PCN: V20-002-48475413-0A

Product Change Notice

Change of manufacturing site for ChipLED part number listed below.

ASMT-CW20

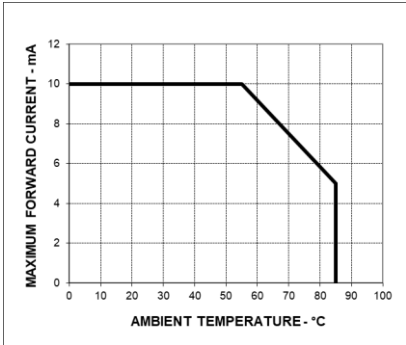
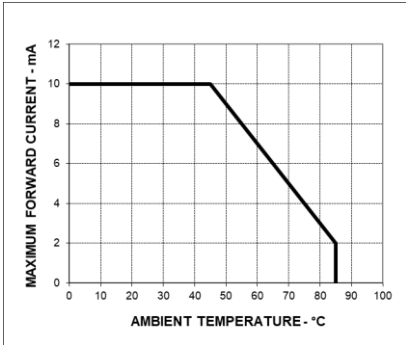
Existing Site	New Site																
Top View																		
Bottom View																		
Derating Curve	 <table border="1" style="display: none;"> <caption>Derating Curve Data (Existing Site)</caption> <thead> <tr> <th>Ambient Temperature (°C)</th> <th>Maximum Forward Current (mA)</th> </tr> </thead> <tbody> <tr><td>0</td><td>10</td></tr> <tr><td>50</td><td>10</td></tr> <tr><td>85</td><td>0</td></tr> </tbody> </table>	Ambient Temperature (°C)	Maximum Forward Current (mA)	0	10	50	10	85	0	 <table border="1" style="display: none;"> <caption>Derating Curve Data (New Site)</caption> <thead> <tr> <th>Ambient Temperature (°C)</th> <th>Maximum Forward Current (mA)</th> </tr> </thead> <tbody> <tr><td>0</td><td>10</td></tr> <tr><td>45</td><td>10</td></tr> <tr><td>85</td><td>0</td></tr> </tbody> </table>	Ambient Temperature (°C)	Maximum Forward Current (mA)	0	10	45	10	85	0
Ambient Temperature (°C)	Maximum Forward Current (mA)

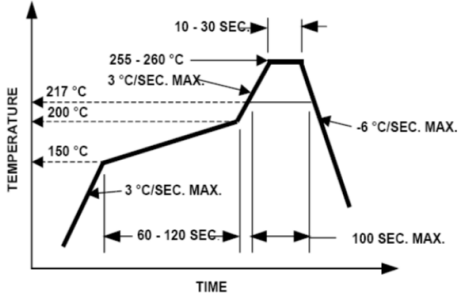
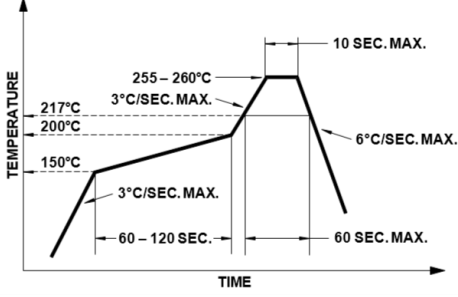
0	10																	
50	10																	
85	0																	
Ambient Temperature (°C)	Maximum Forward Current (mA)																	
0	10																	
45	10																	
85	0
